Addendum Number Two
To The Drawings and Specifications for
Juvenile Services Building
RFB Bid Number: 26-0021, Sedgwick County, Kansas

Issued: October 23, 2026

HANNEY & ASSOCIATES ARCHITECTS
1726 South Hillside, Wichita, Kansas

NOTICE TO BIDDERS
You are hereby instructed to include in your bids the following changes and/or corrections to the Drawings and Specifications for the **Construction of the New Juvenile Services Building at 881 S. Minnesota, Wichita, Kansas 67211.**

P1.1

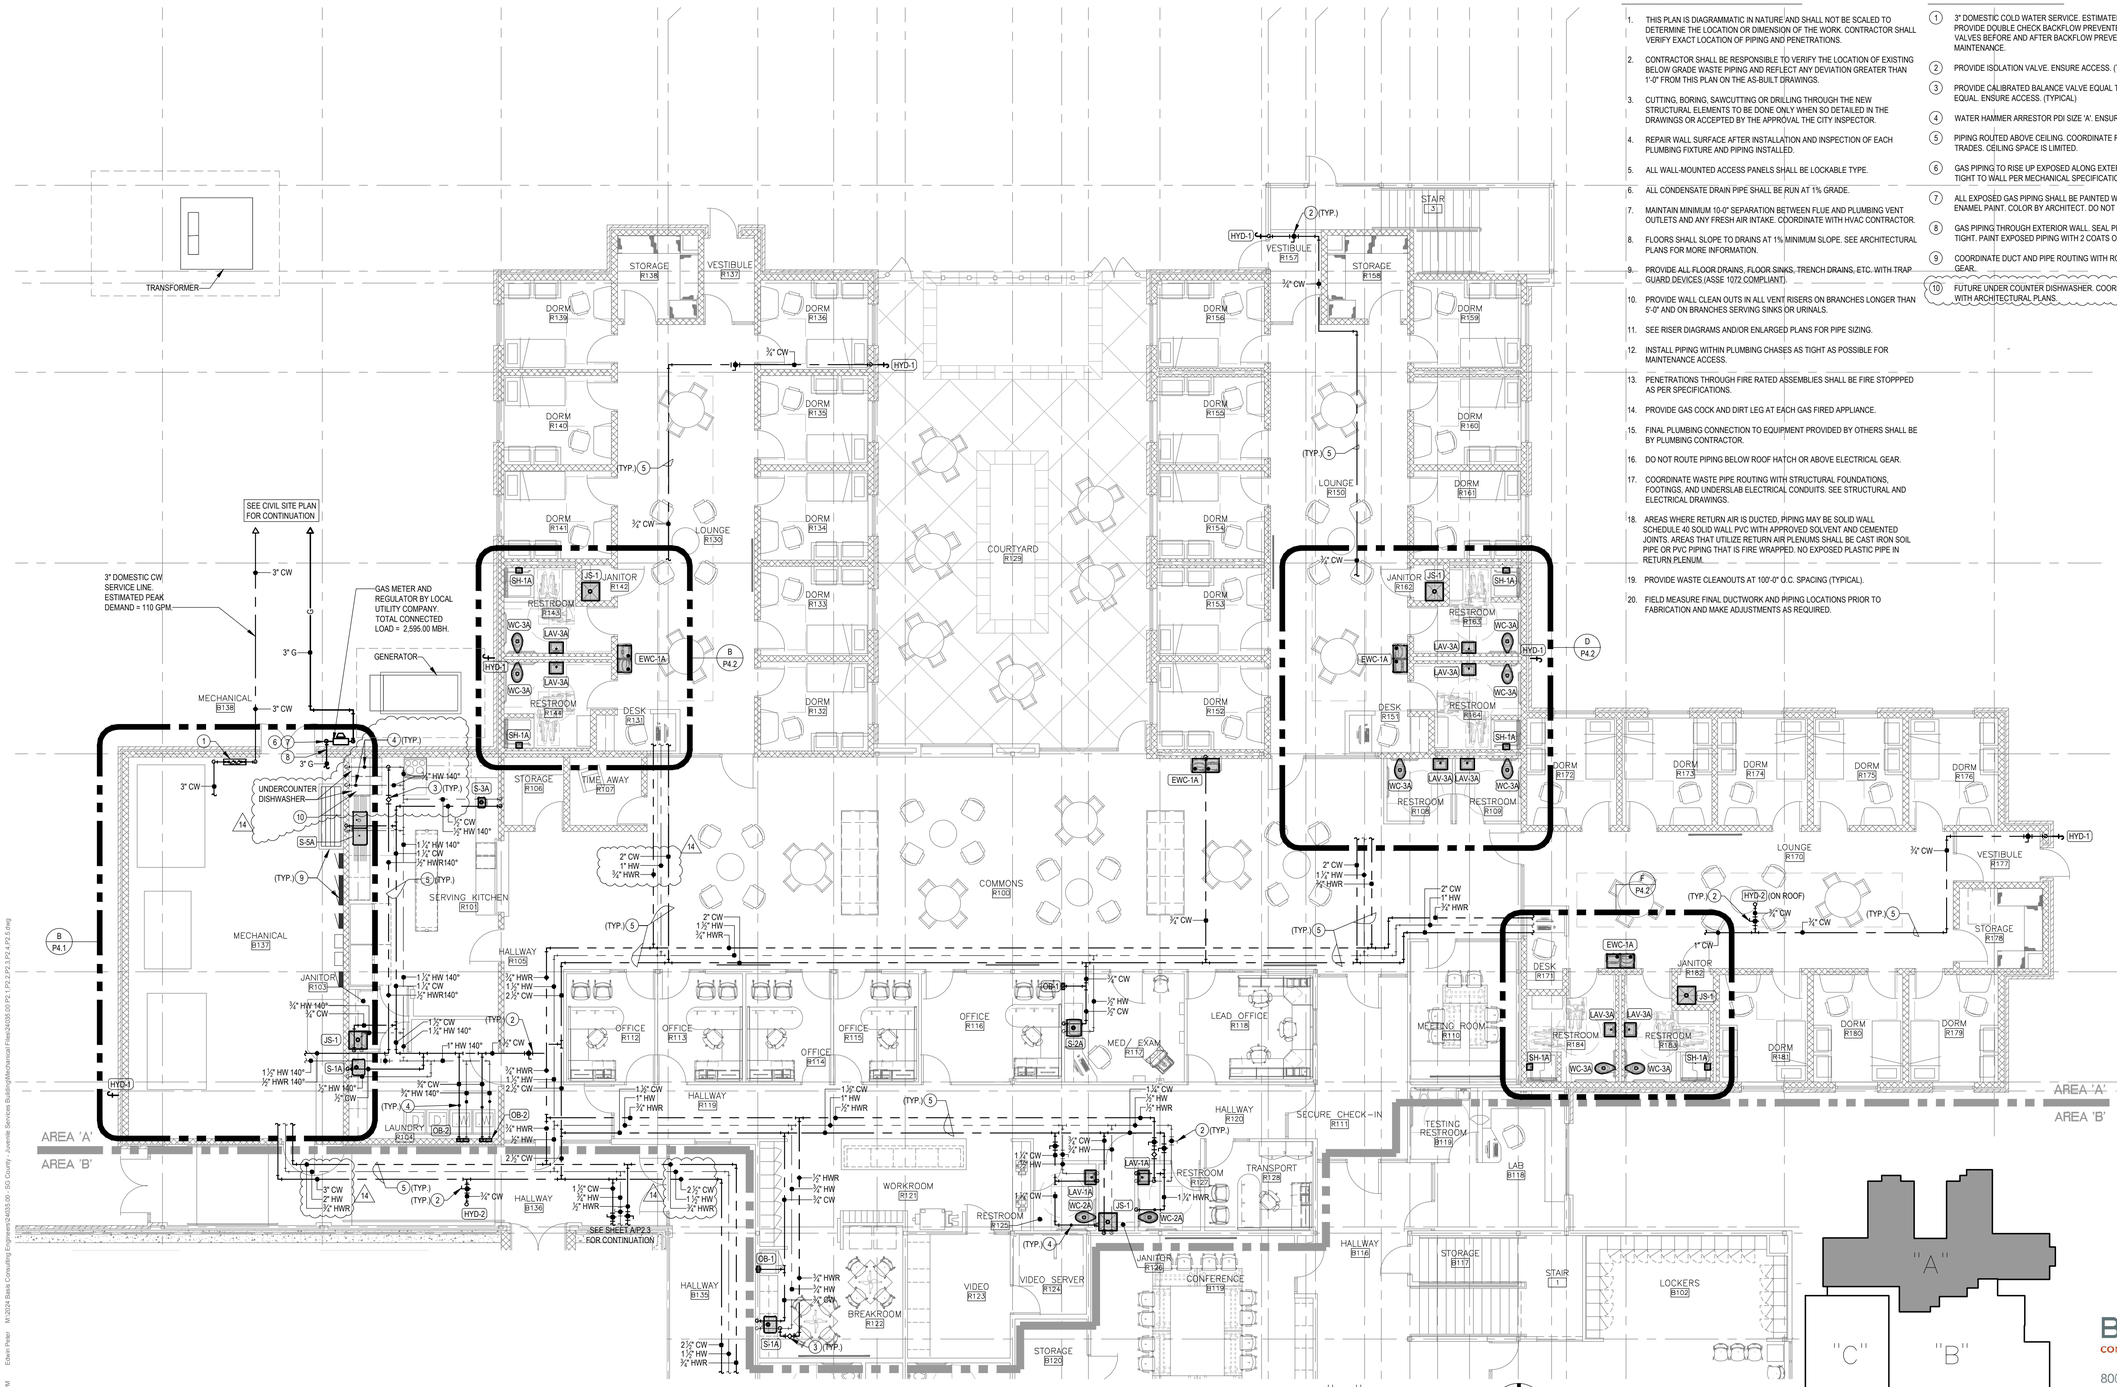
3.22 Sheet P1.1: See clouded changes.
Added 3” floor sink and associated grease waste and vent piping for fixture. Floor sink to serve future/2nd undercounter dishwasher in Serving kitchen-101.
Clarification: Floor sink size to be 3” for 1st undercounter dishwasher in Serving kitchen-101.
Added plan note #13.

P2.1

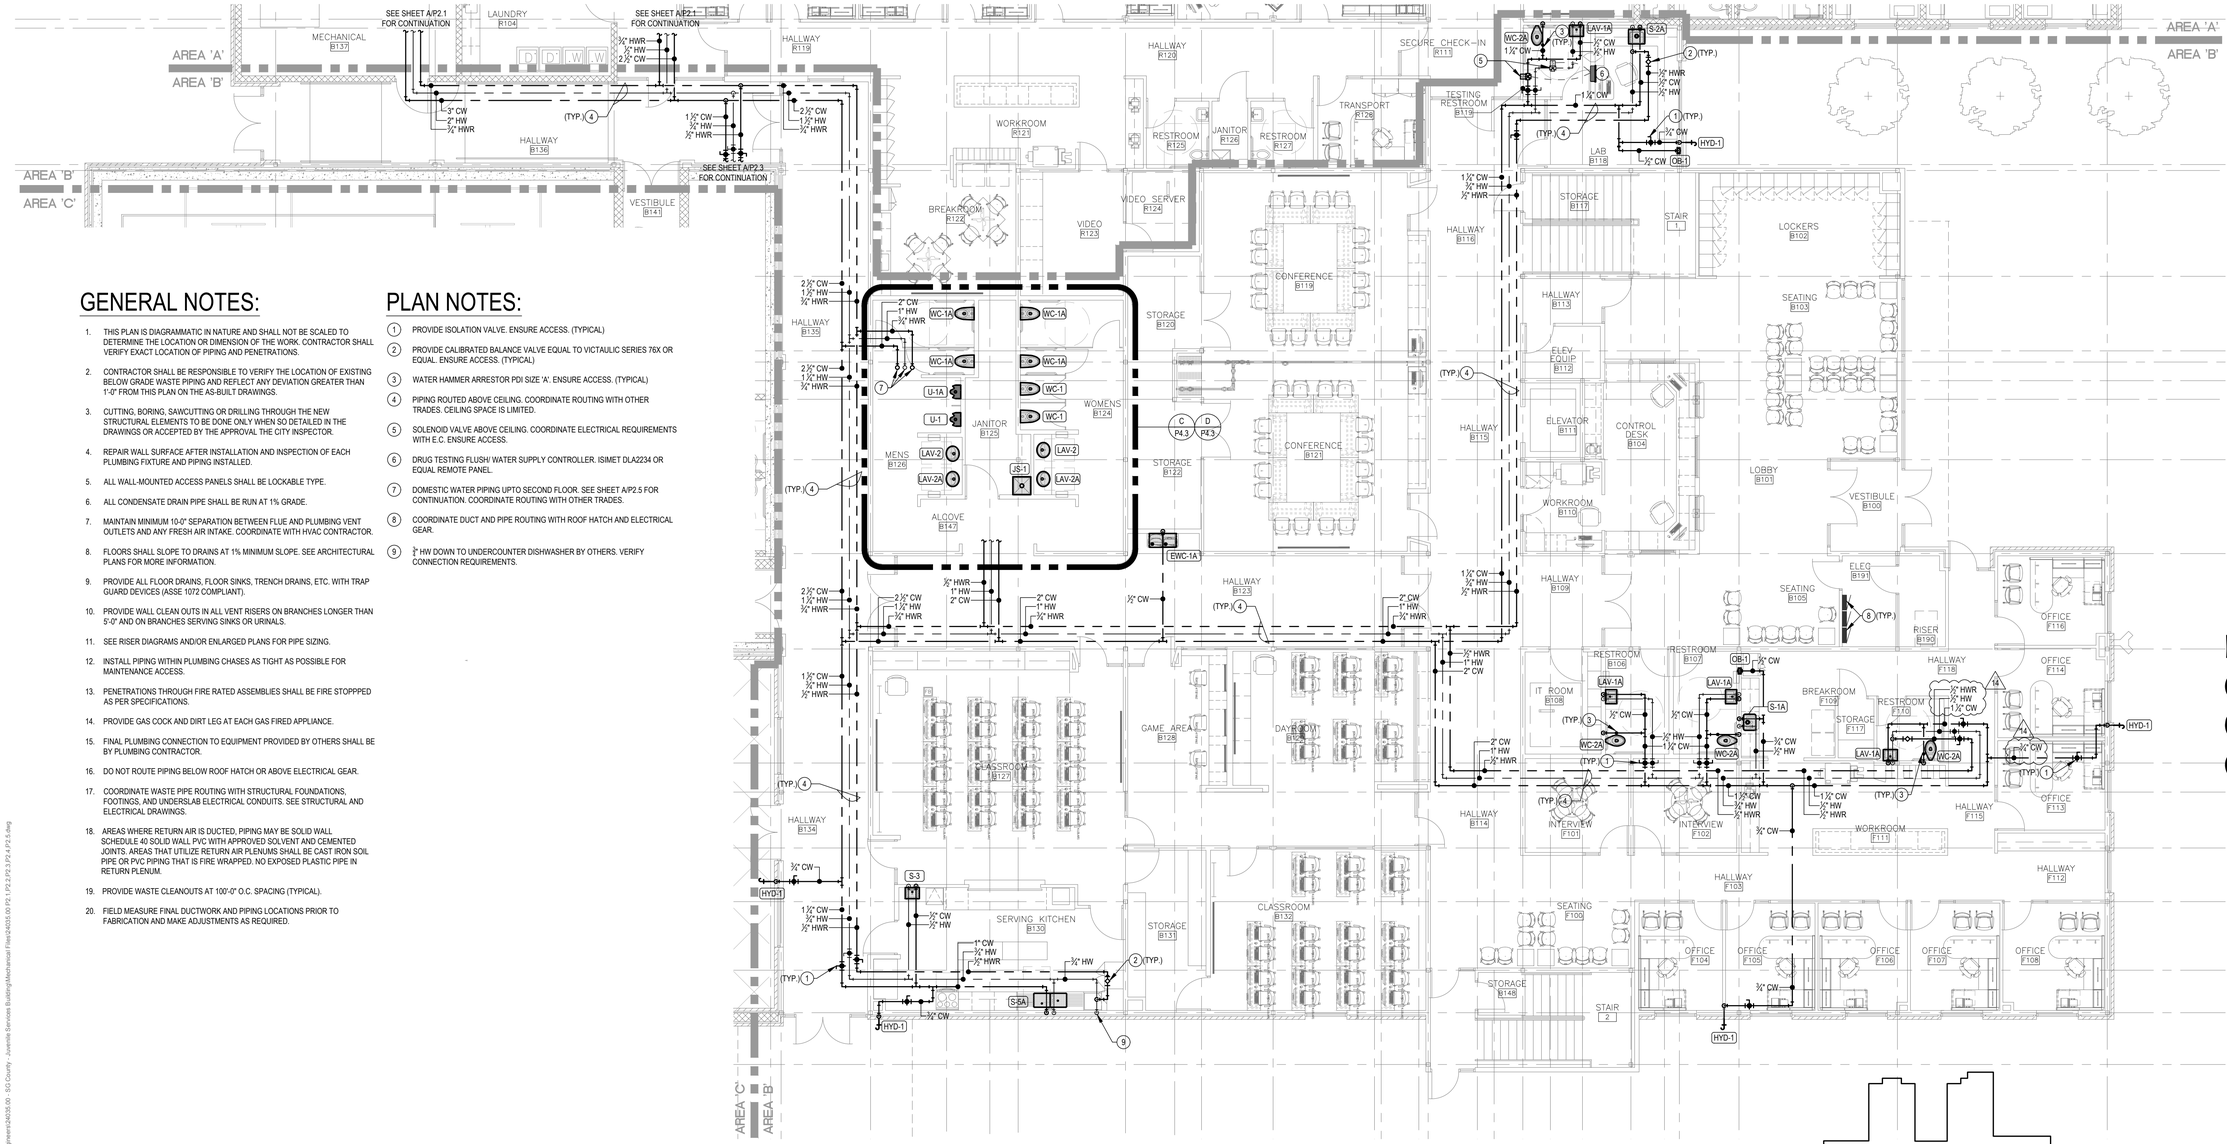
3.23 Sheet P2.1: See clouded changes.
Updated pipe size & tag to reference the right piping system on the plans.
Added ¾ HW 140° piping to serve future undercounter dishwasher in Serving Kitchen-101.
Added plan note #10.

P2.2

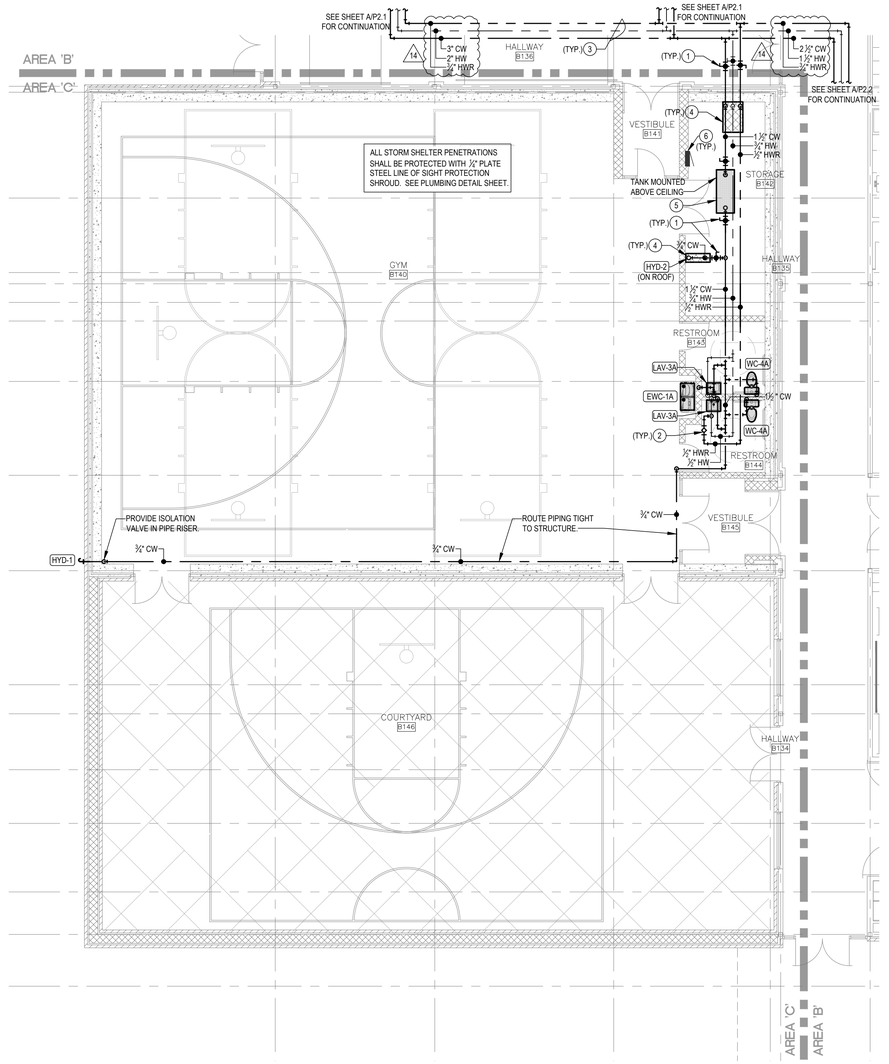
3.24 Sheet P2.2: See clouded changes.
Updated pipe size & tag to reference the right piping system on the plans.

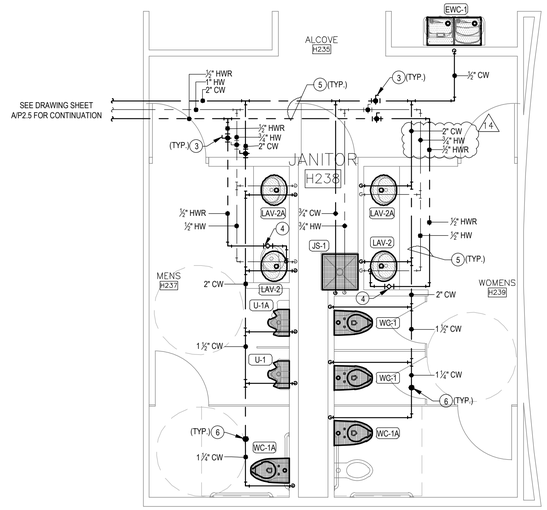
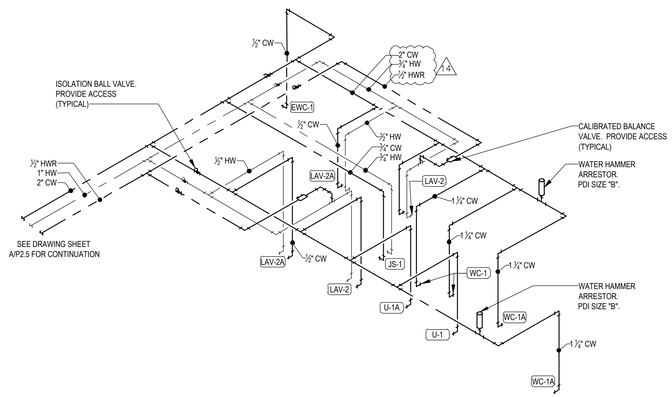
3.26 Sheet P4.4: See clouded changes.
Updated pipe size & tag to reference the right piping system on the enlarged plan Views C & D.
